Notice of Allowability

10/727,531

SAKAMAKI ET AL.

EXAMINER'S AMENDMENT

FIG. 2

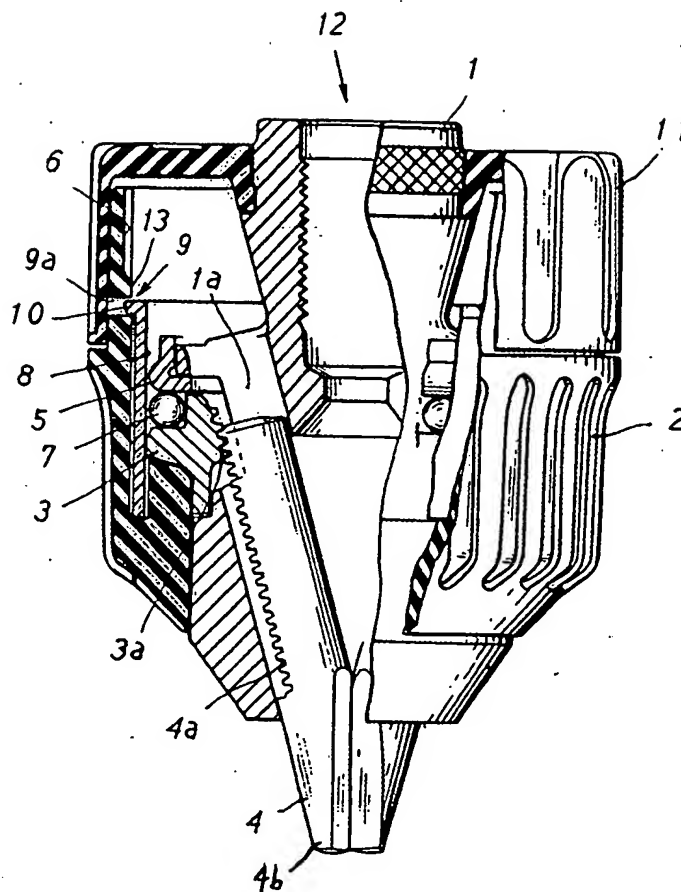
(a) Add character reference "4b" to Figure 2 identifying the "tip end" of the jaws. In order to avoid abandonment of the application, applicant must make these above agreed upon drawing changes.
